3.1a Lot 32 (1324) Thomas Road, Oakford - Proposed Oat Mill Operating Facility and Associated Buildings and Structures - 'Industry-Rural' – DAP/25/02840

**Part C – Item 3.1a – LOT 32 (1324) THOMAS ROAD, OAKFORD –  
PROPOSED OAT MILL OPERATING FACILITY AND ASSOCIATED  
BUILDINGS AND STRUCTURES - ‘INDUSTRY-RURAL’**

**Form 1 – Responsible Authority Report  
(Regulation 12)**

D	29-10-2025	PROPOSED LAYOUT AMENDED	PROJECT:	DRAWN BY:	
C	19-05-2025	PROPOSED LAYOUT AMENDED	1324 THOMAS ROAD, OAKFORD		
B	06-12-2024	BRANDING UPDATED	TITLE:	N.M.	
A	13-10-2023	ISSUED FOR REVIEW	LOCALITY PLAN - 800M RADIUS		
No	DATE	AMENDMENT	DRAWING NUMBER:		
			KC01712.000_S01

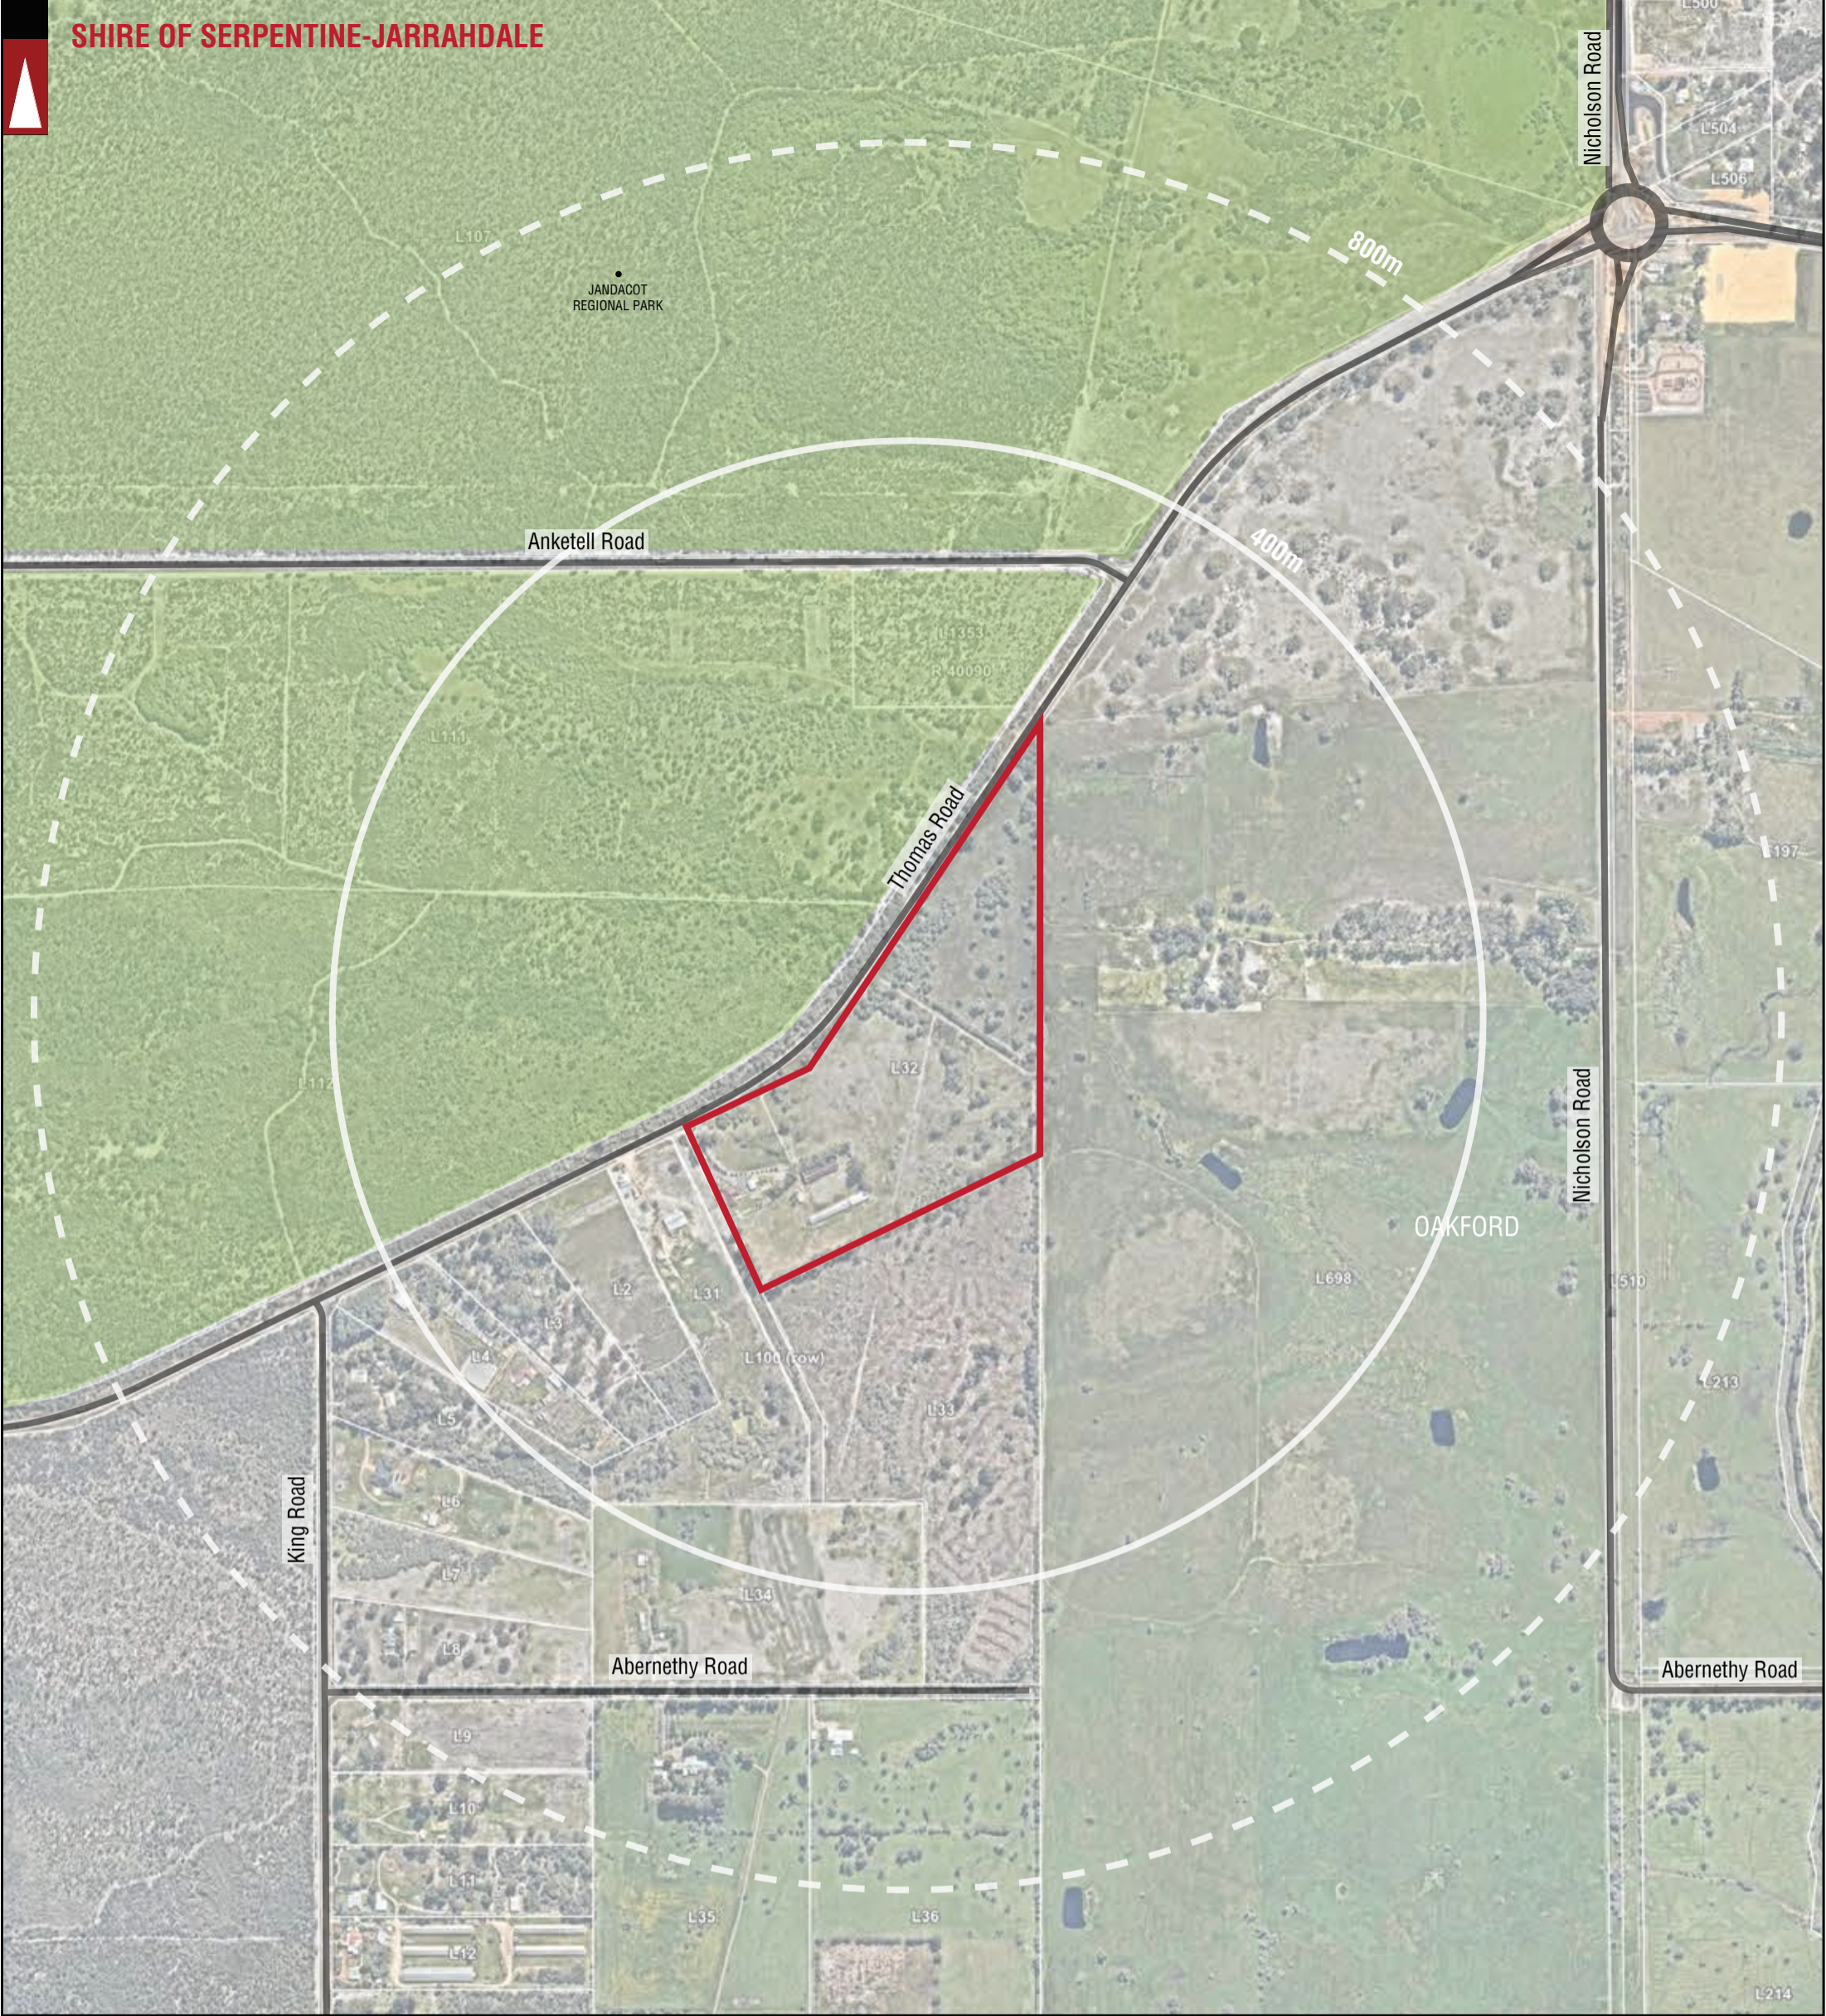
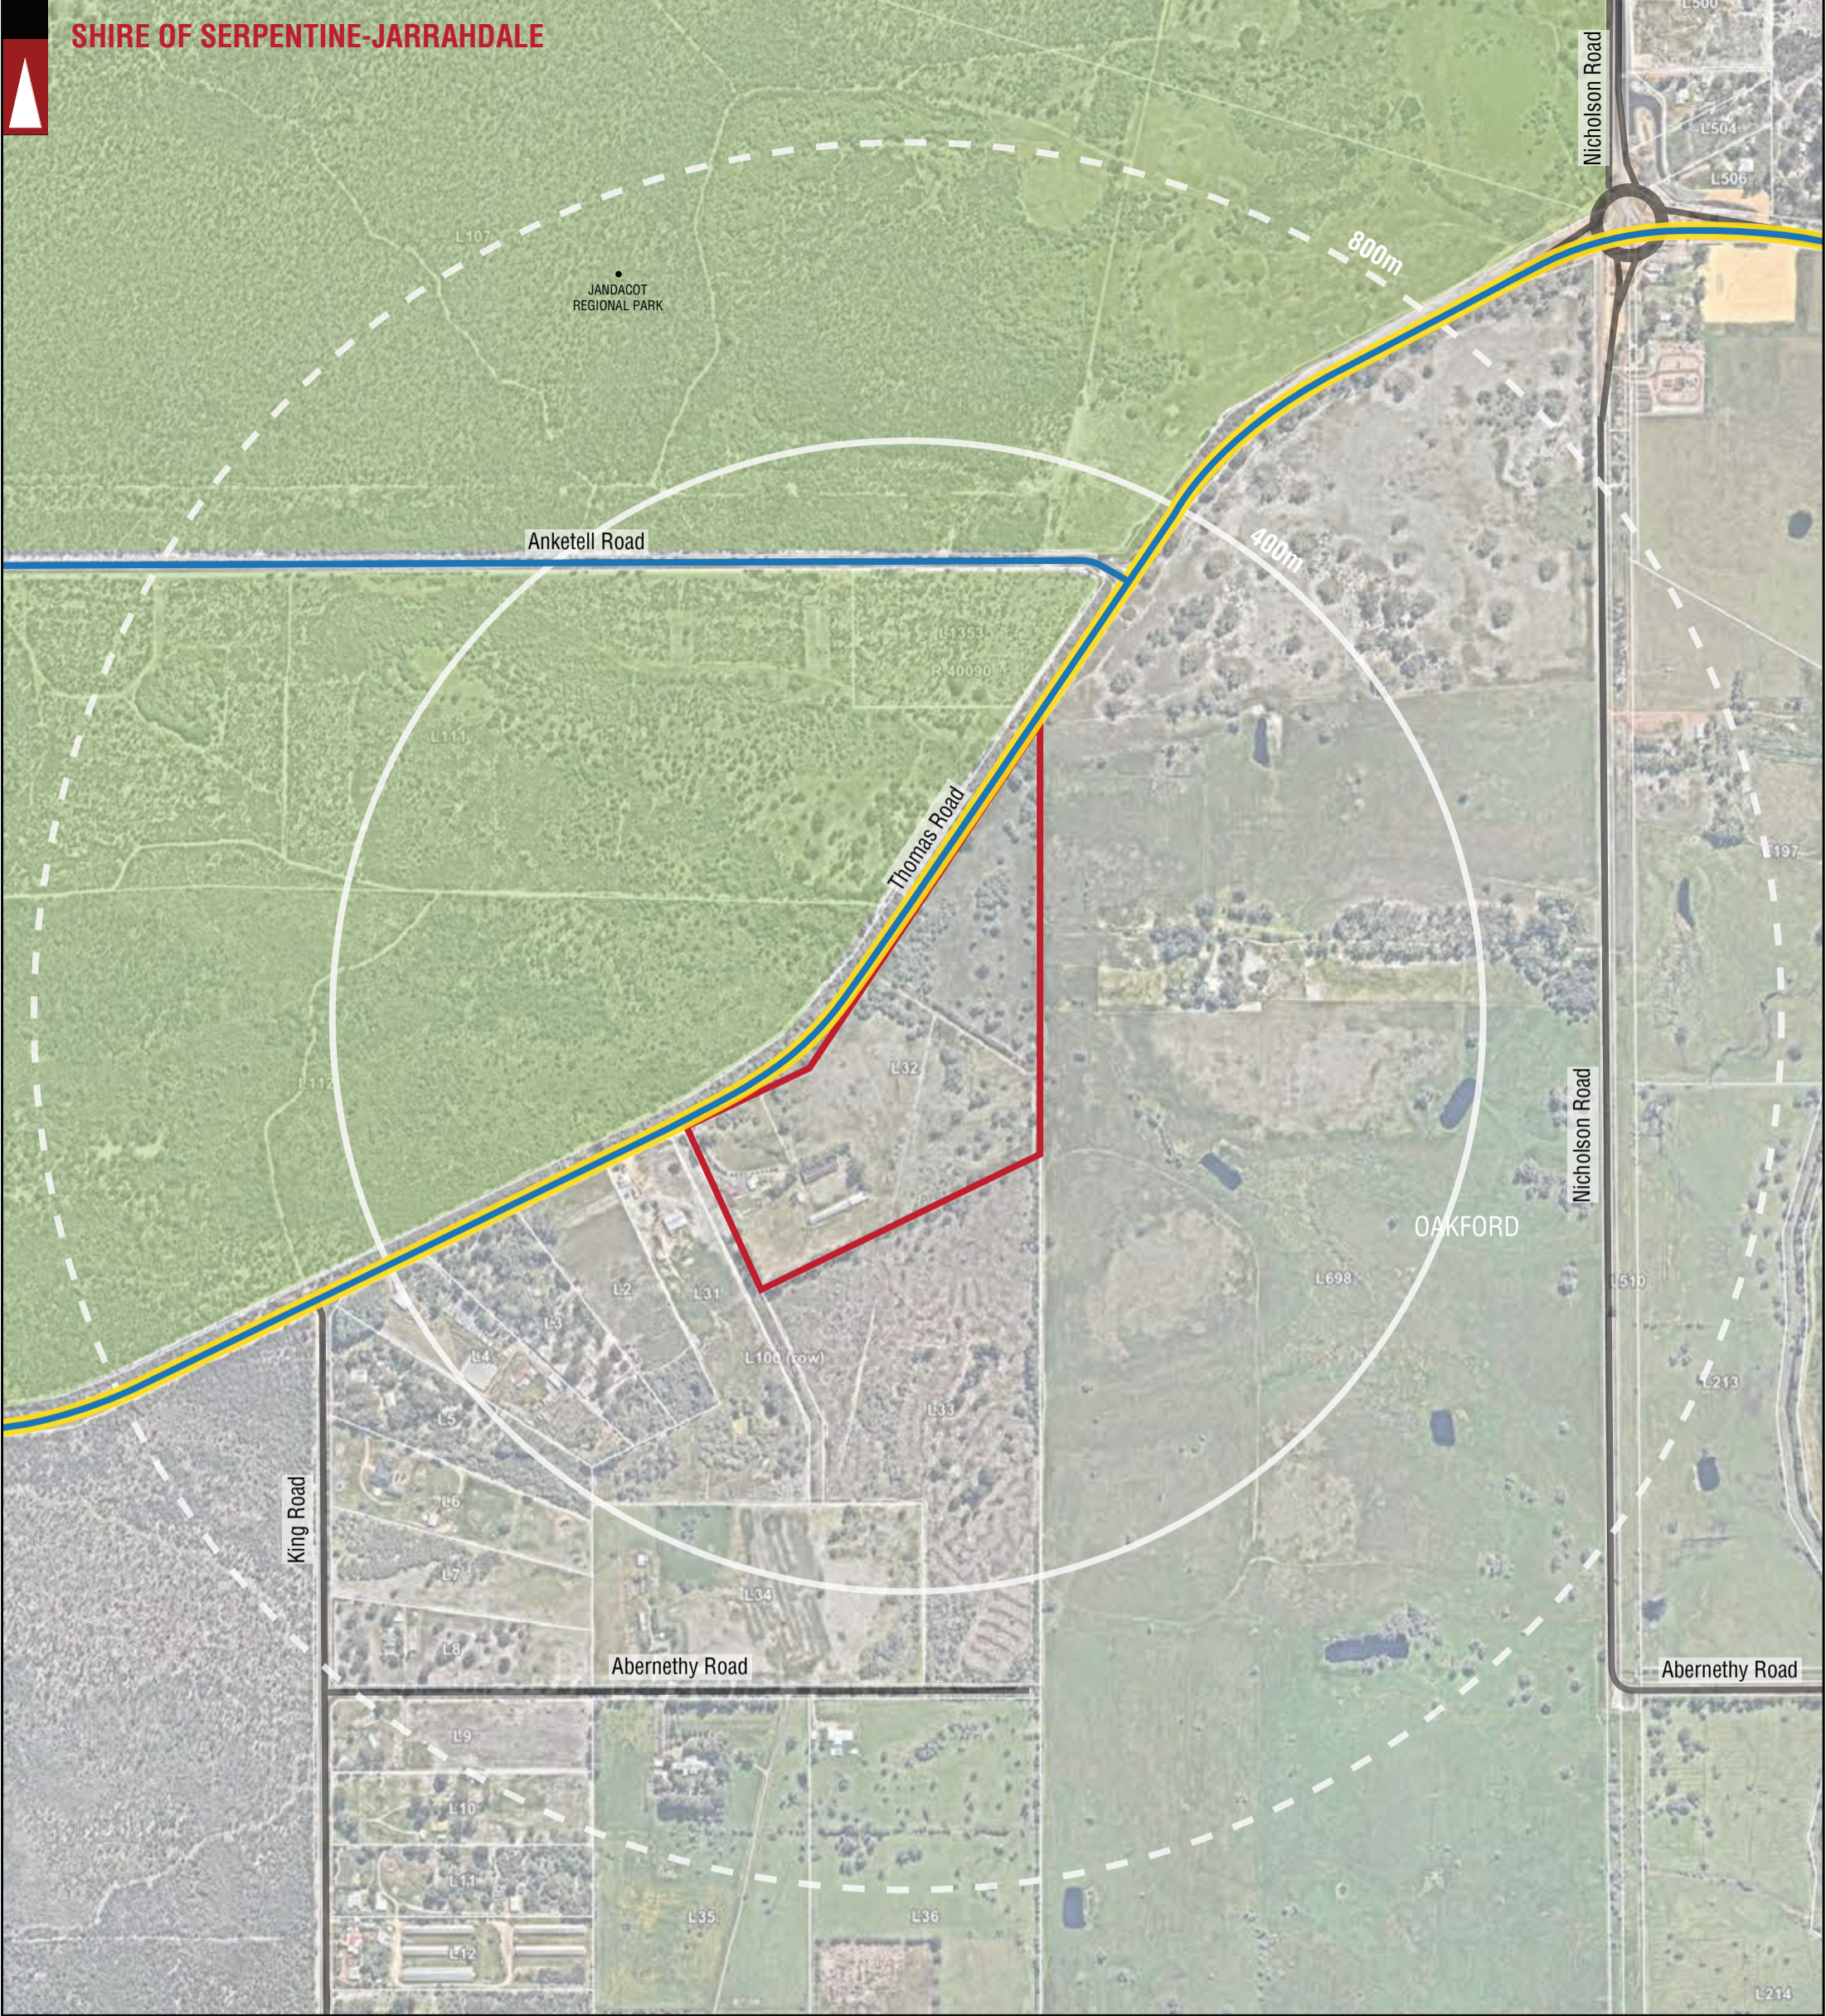
- Left-turn island angle not adjusted to 70-degrees to Thomas Road. Observation angle for left-turn exit is extremely poor and does not meet [Main Roads Supplement to Austroads Guide to Road Design – Part 4A](#), Section 6.1.3. Also refer to AGRD Part 4A, Figure C1 1 which demonstrates how vision becomes increasingly difficult at this type of observation angle.
